**PROJECT DATA**

**SITE DATA:**  
 SITE ADDRESS: 3147 EAST GETTYSBURG AVENUE, FRESNO, CALIFORNIA 93726  
 APN: 427-261-25  
 LAND AREA: 2.99 ACRES NET (266,884 SQ. FT.)  
 ZONING DESIGNATION: O (OFFICE)

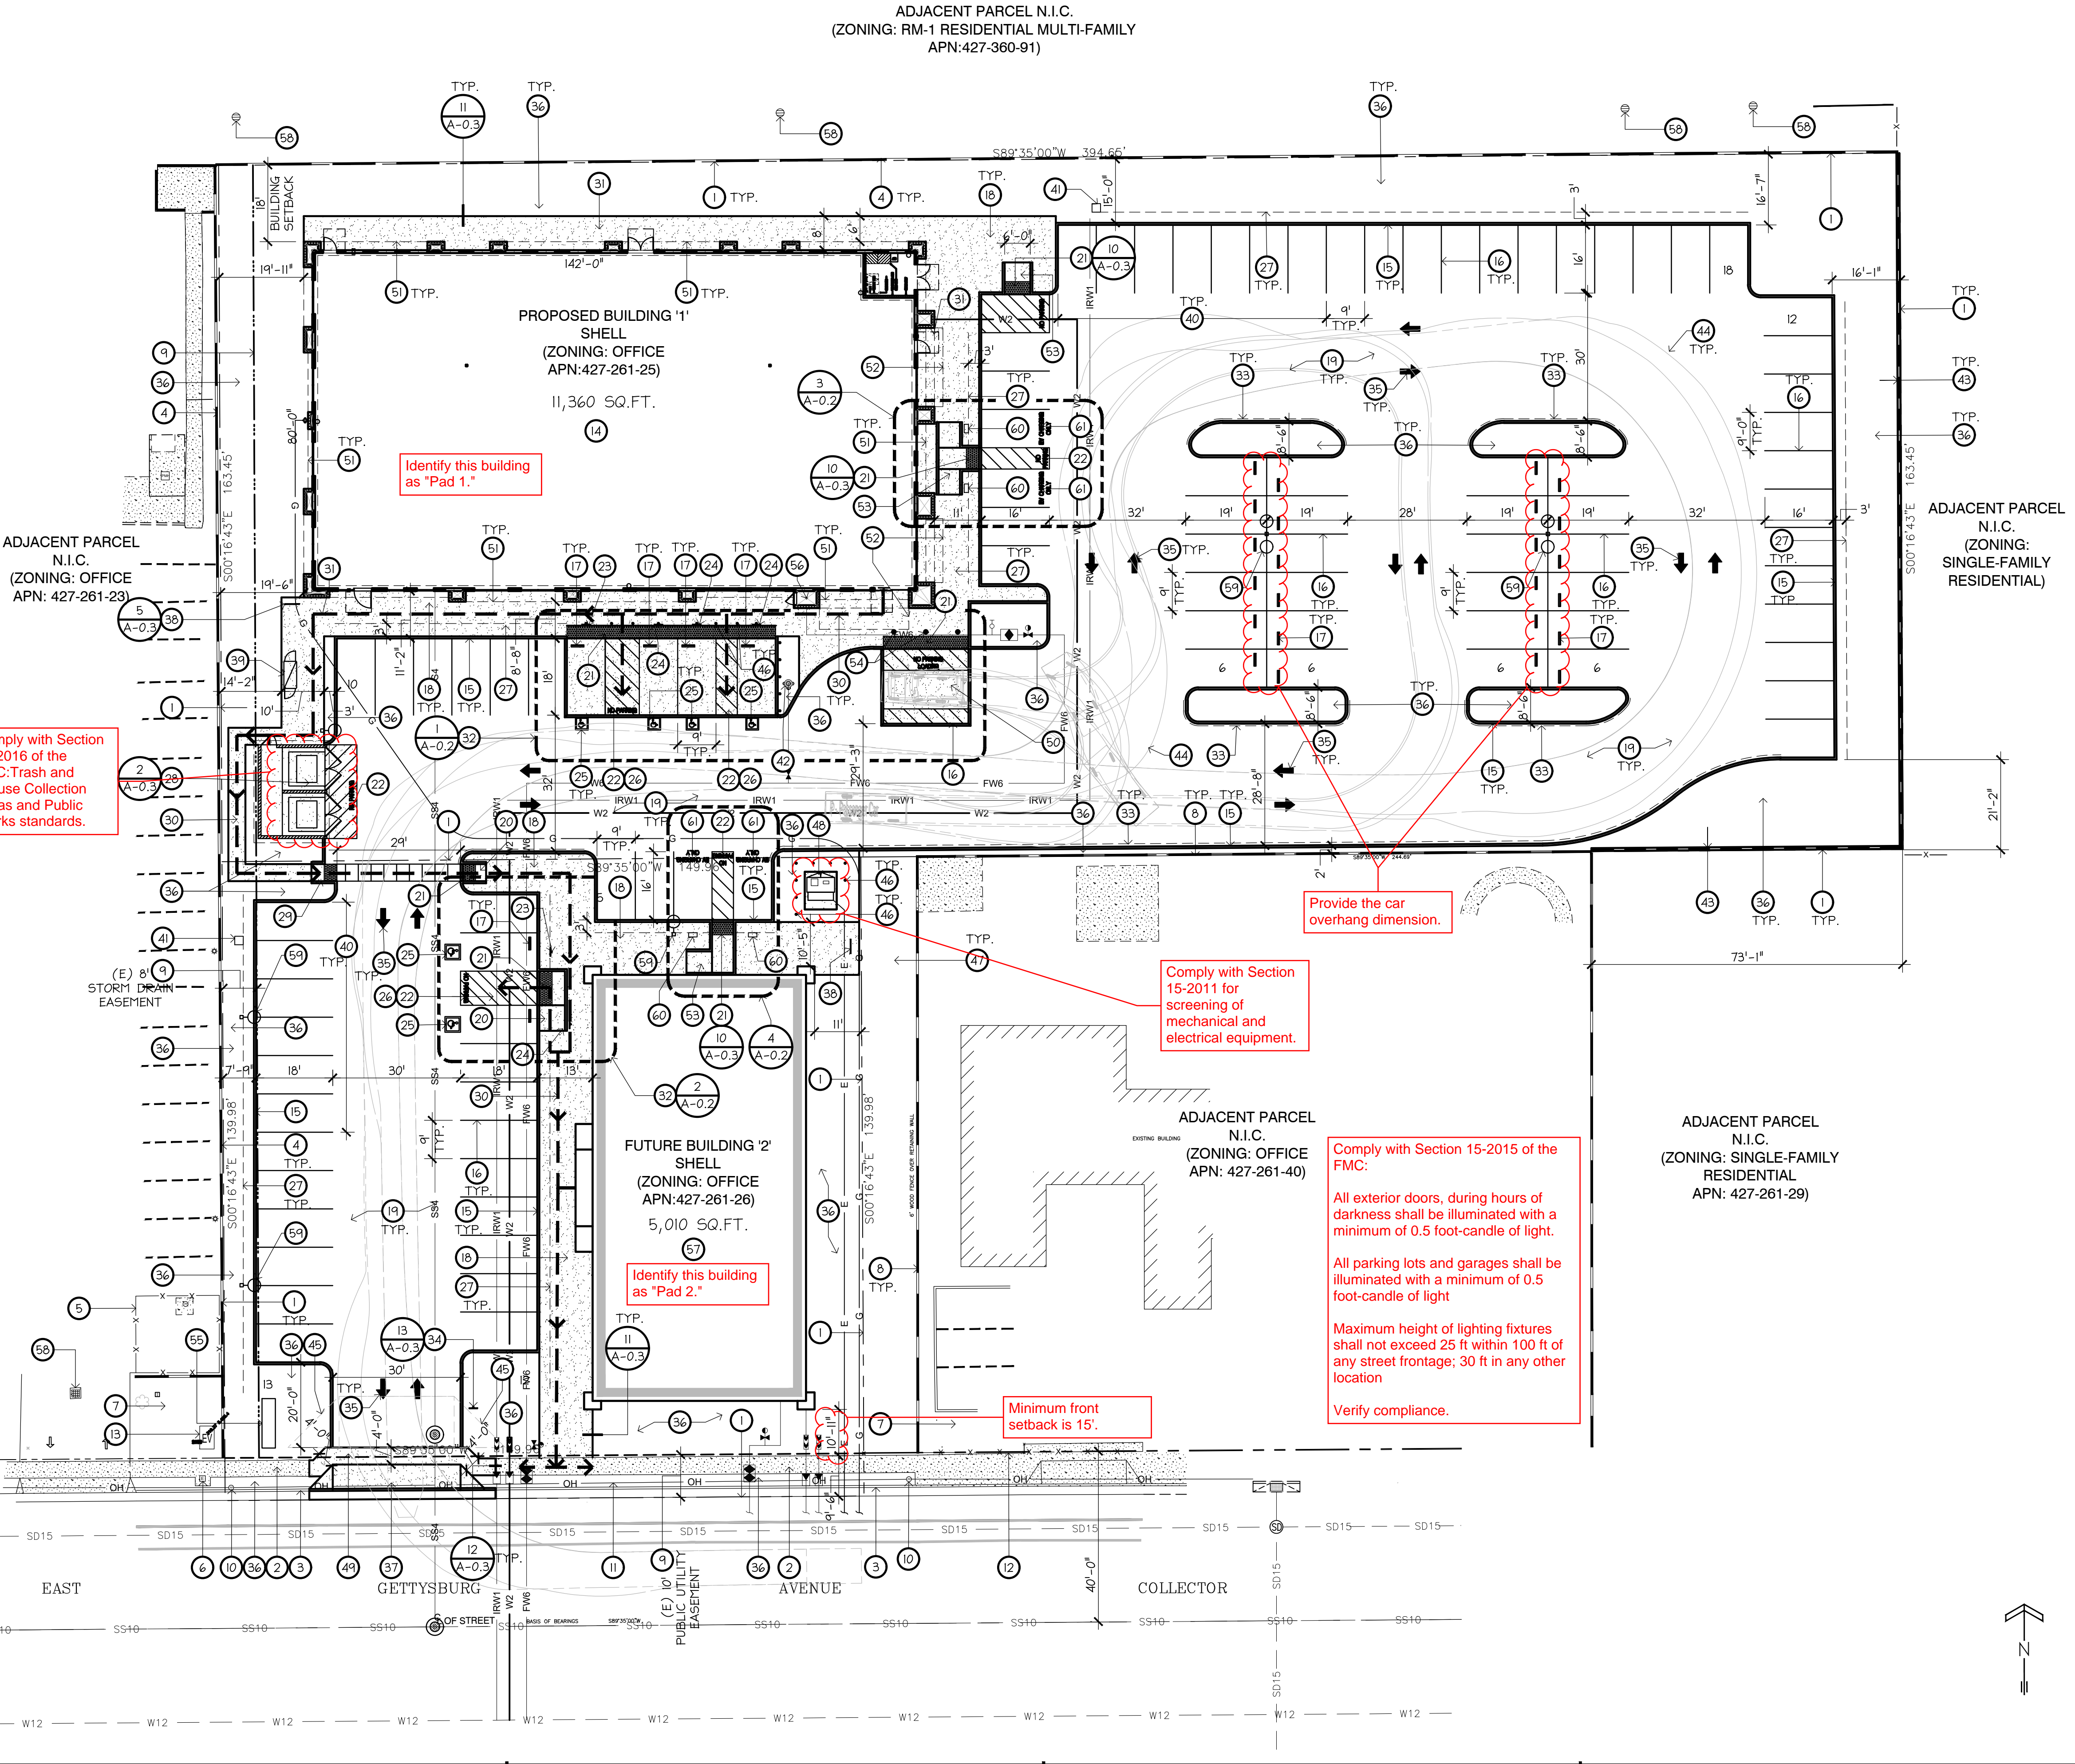
Current Release Date	01-17-2023
Planning Submittal	01-17-2023
Plan Check Submittal	01-17-2023
